## High Street revitalisation submissions and responses

Attachment 1 – Proposed changes to mid block – Paul Dallimore. Submission 40

Attachment 3 – Proposed alternative plan for southern block

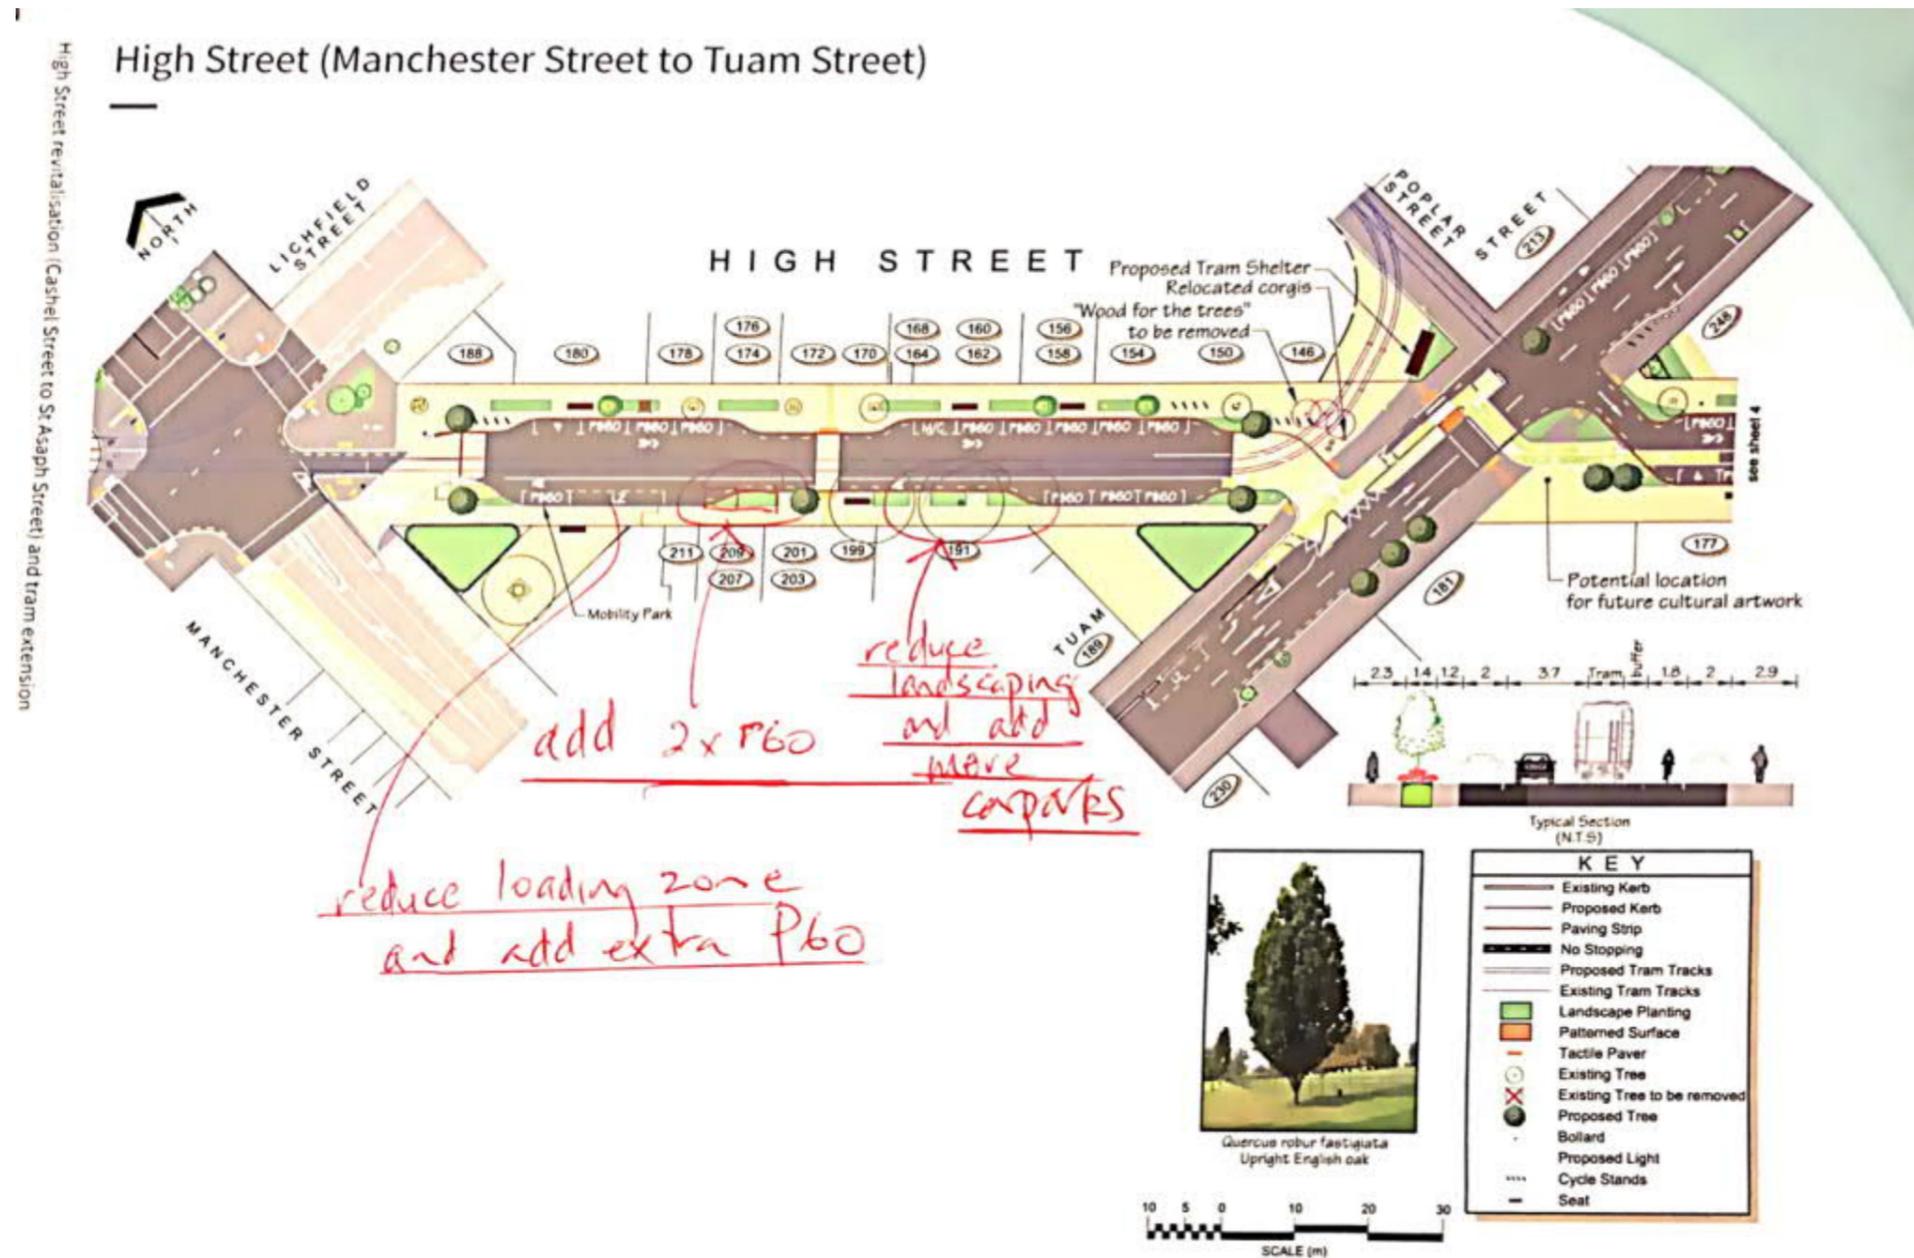
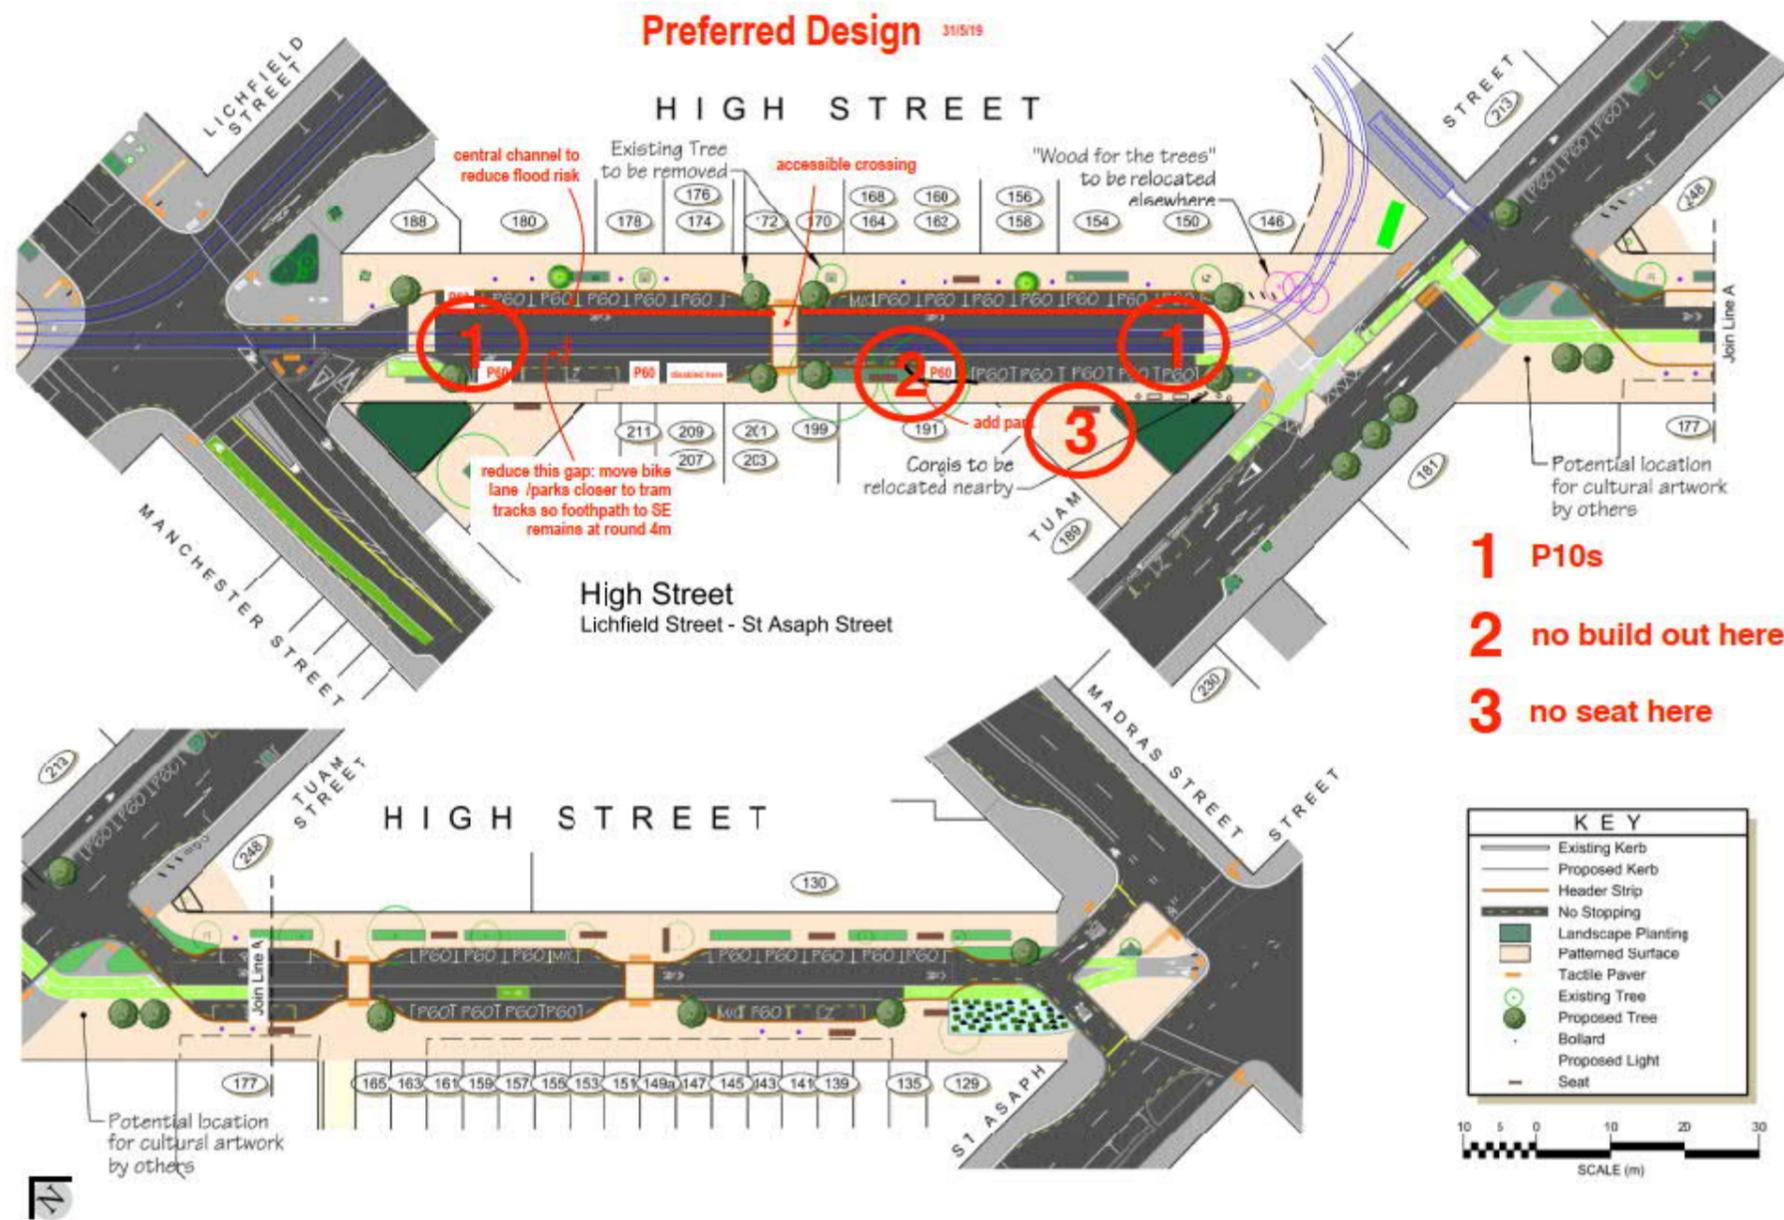
40	24950	<p>Please see Attachment 1 below this table.</p> <p>Please find attached a plan with suggested amendments. It is important to maintain as many street car parks as possible in this area as the buildings in this area do not have off street parking. I feel the landscaping can be reduced without compromising the look and feel of the street.</p> <p>I am overseas hence the submission is less formal.</p>	<p>Thank you for your submission.</p> <p>The Hearings Panel will consider your proposal as part of your submission and make its recommendations to Council.</p> <p>The proposed scheme seeks to achieve a balance between pedestrian amenity and a low speed / low traffic flow environment supporting necessary servicing and parking needs of local businesses.</p> <p>The areas you have identified on the plan are unable to provide for additional parking without the removal of two existing trees. Car parking in this location would result in a footpath width of less than 3 m which restricts the accessibility of the footpath and potentially impact on the required verandas as part of district plan matters. The areas</p>	Paul	Dallimore	Sachs Coburg International

The underlying plan also includes a number of additional car parks. On the western side of the street these additional car parks result in a footpath width of less than 3m which restricts the accessibility of the footpath and potentially the required verandas as part of district plan matters. The consultation plan has reduced the location of car parking near to the building line and instead only located them adjacent to the triangles where there is more space. On the eastern side of the street, the additional car parks have been added that reduce/eliminate the landscape planting at the thresholds of the street and crossing point. The project seeks to balance all aspects including landscaping, pedestrian amenity and parking needs.

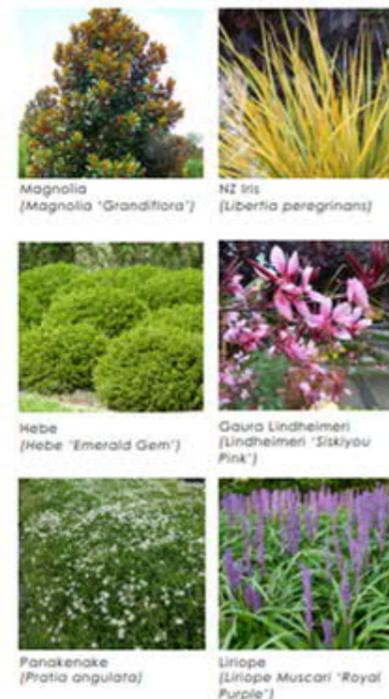
- A Landscape planting with a mix of low growing natives and exotics
- B Existing trees retained on the North side of the street
- C Proposed street trees on south side of the street to be small to medium sized. Suggested species including Magnolia, Maple or Flowering Cherry
- D Crossing and safety splays with patterned surface to create a 'courtesy crossing'
- E Open landscaped parklets (6x3m) with seating and glass panels to provide barrier from the road
- F Bike parking space (6x3m) - 8 spaces each
- G Tactile Paver at crossing points
- H Mobility parking bay
- I Loading zone
- J 300mm Dish channel to capture runoff
- K 150mm flush kerb to allow ease of movement across street
- L Cycle lane - with 200mm dividing line between cycle lane and carparking
- M Rain garden

- A** Canopies on the South side of the street, Soffit at 2.8m from footpath level, 2.8m from buildings boundary, 500mm tall
- B** Bench seating and Landscape strip planted with a mix of low growing natives and exotics and lancewoods to add a vertical element on North side of the street

The proposal includes three crossing points, one at either end of the street and one mid-block. These include build-outs to provide pedestrian visibility around the parked cars. However the kerb returns on these are not designed to standard and would make it difficult for people to use car parks. The build-outs shown in the proposed plan are essentially the same as those used on St Asaph Street with a small rounding used. These regularly get damaged by cars parking in the adjacent space, people find them hard to use and Council has received significant complaints about these. While it is accepted that this is a level surface and therefore vehicles can drive over the 'kerb' it still needs to provide protection for pedestrians waiting to cross the road and separate manoeuvring vehicles from the waiting pedestrians.

The proposal includes an increase in parking spaces above that which was previously proposed in the Council's consultation plan. On the Duncan's Building side of the road this will lead to more vehicles driving over the contra-flow cycle lane which will increase the risk of conflict with cyclists. It will also increase the risk of cyclists having car doors opened into their path of travel. Typically it is the driver side door which is opened into the cycle lane but in this instance it would be the passenger

side door. People exiting the vehicle on the passenger side will be less likely to expect cyclists as it would not be the norm for them. The plan which went to consultation included a buffer adjacent to the cycle lane of approximately 0.8 metres to overcome this door issue. We note that this has been removed in the plan forming Attachment 3 with a smaller 200 mm buffer provided and a narrower cycle lane provided at 1.6 metres. These widths are not sufficient for a contra-flow cycle lane. The total width of parking space, traffic lane, cycle lane and buffer should not be less than 9.8 m (i.e., 2 x 2 m parking space, 3.2 m traffic lane, 1.8 m cycle lane, 0.8 m buffer).

The available width for pedestrian footpath, landscaping and amenity is 10.3 m (based on the road width being 20.1 m). The preferred minimum footpath movement corridor is 3 m within the central city. Therefore, the resulting space for landscape and amenity is 4.3 m. Where landscaping / street furniture is provided the minimum distance between an adjacent car park and this must not be less than 1.2 m, to provide for door opening space. If amenity / landscaping is provided on both sides of the street at the same location along the street then the available space for the amenity / landscaping is therefore 1.9 m, which is insufficient space.

The Christchurch Central Streets and Spaces Design Guide, informed by significant public feedback, identifies the southern block of High Street as a key walking and cycling street. The aim of the project is to create a street that provides this amenity and appearance. The predominance of vehicle parking in the proposed plan detracts from this objective.

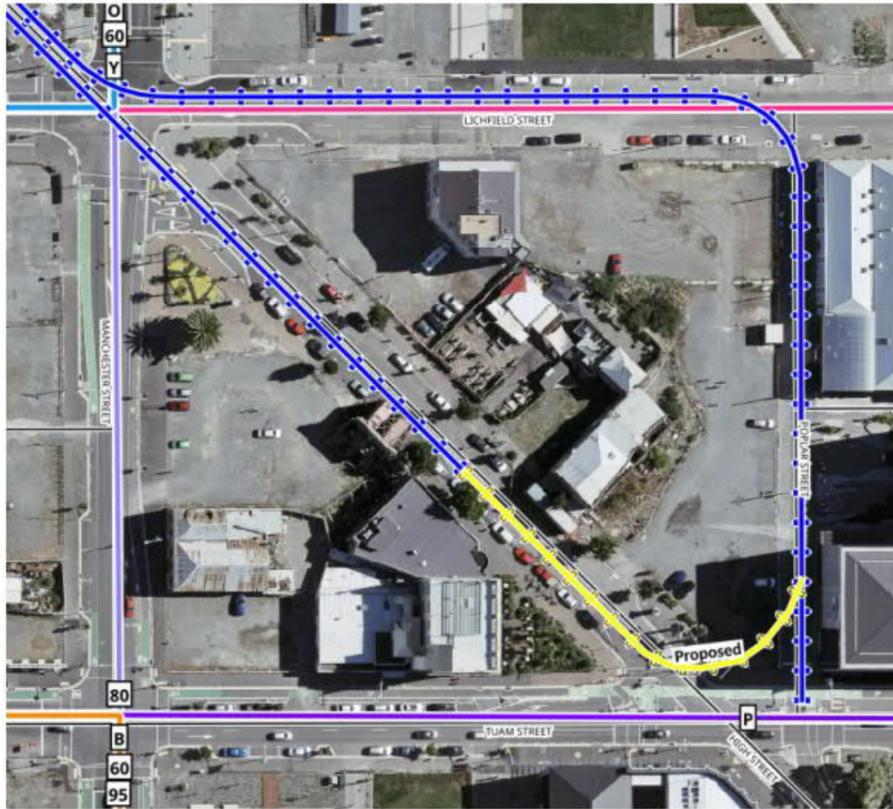
- Because of the tramlines, this is a narrow street section.
- Because of this narrowness, it is hazardous for cyclists to pass down the street when having to pass cars and avoid the tram lines. Perhaps this is why the proposal make no special mention of cycles.

- The actual driveable section for vehicles along the tram tracks is only about 100 metres long.
- The section outside Strange's Building is currently reserved for pedestrians, and I presume this will not change.

- At the Manchester Street end, the street is left in left out only for traffic. I presume this will not change.
- The section of High Street immediately north of this is a pedestrian mall.

- There is a large block which used to be the Centra Hotel site and which can clearly be seen as an empty area to the right of the Cashel Street – High Street intersection. I do not know what is planned for this area, such as whether the hotel is proposed for rebuilding.

4. Any mobility parks or motorcycle parking.
3. The raised crossing humps pose questions about how they can be made to work with tram tracks crossing through them, maintaining enough clearance under the tram through which four tram rails must pass, and without creating additional trip hazards for pedestrians. Obviously if the street is closed to traffic, these humps will not be necessary.

The proposal does not include any speed bumps or raised table across the tram track.

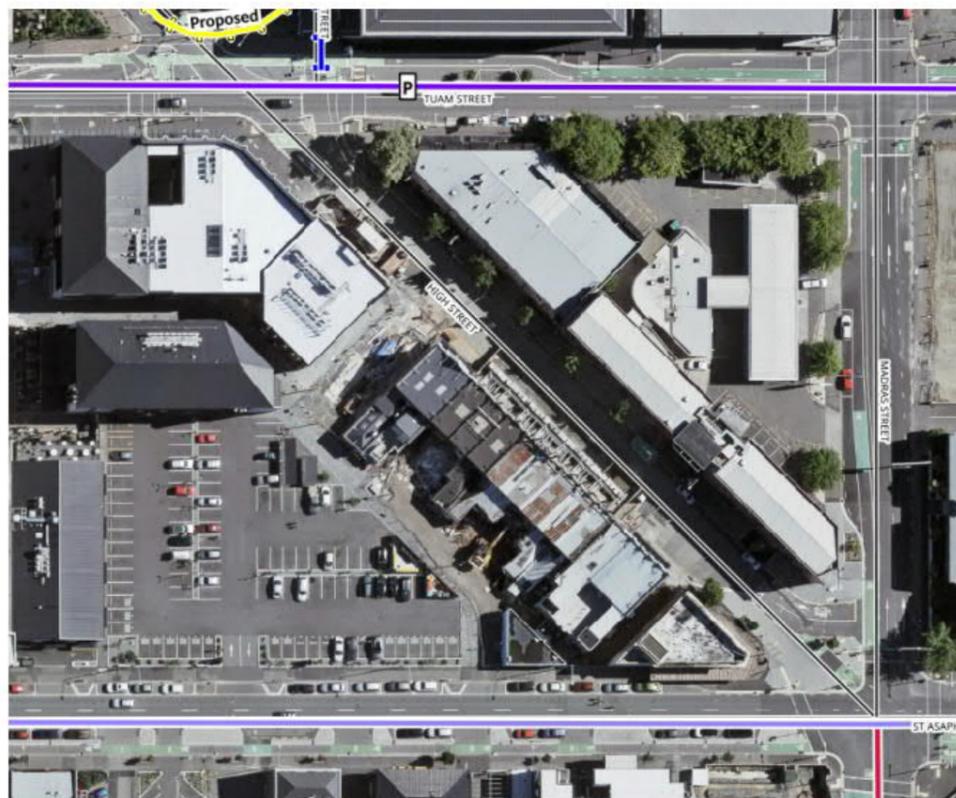
- This area has only one tramline along the northward side of the street.
- This makes the northward side of the street hazardous for cyclists with cars manoeuvring around the carparks.

- How does the Council propose to enforce speed limits? These speed limits appear to be a cop out because of the hazards that are highlighted due to the difficulty of accommodating all the different modes with tram tracks running through these areas creating additional cyclist hazards.
- Both ends appear to be left in left out for vehicle traffic and I presume this will not change. This is one of the reasons the intersection on Tuam Street can be simplified.

1. Due to the narrowness of the northbound side of the street with the tramlines posing hazards to two wheeled vehicles, this section should be closed to vehicles entirely.
  1. This affects four P60 parks and a loading zone.
  2. The cycle lane proposed should be separated from the footpath and tram lines, instead of being painted on.
2. This section of High Street should therefore be one way only, on the southbound side, insofar as motorised traffic is concerned.
3. This area currently has many empty sites which have yet to be developed. Planning should ensure that these sites provide adequate offstreet parking for their business needs, leaving the on street parking on the south side only, for mobility, loading zone, motorcycle and a small number of car parks.

1. Remove the parking and loading zone along the northbound side
2. Build the cycle lane as off-road. These two measures combined will ensure the safety of cyclists using the cycle lane along this side of the street.
3. Ensure off street parking is required/provided for all businesses

The project team considered an option to create a one-way street; however, the local businesses and landowners did not support this option because of access issues. It also would limit access to Manchester Street from High Street with the preferred one-way direction being anti-clockwise – vehicles exiting High Street would only be able to turn north into Manchester Street.
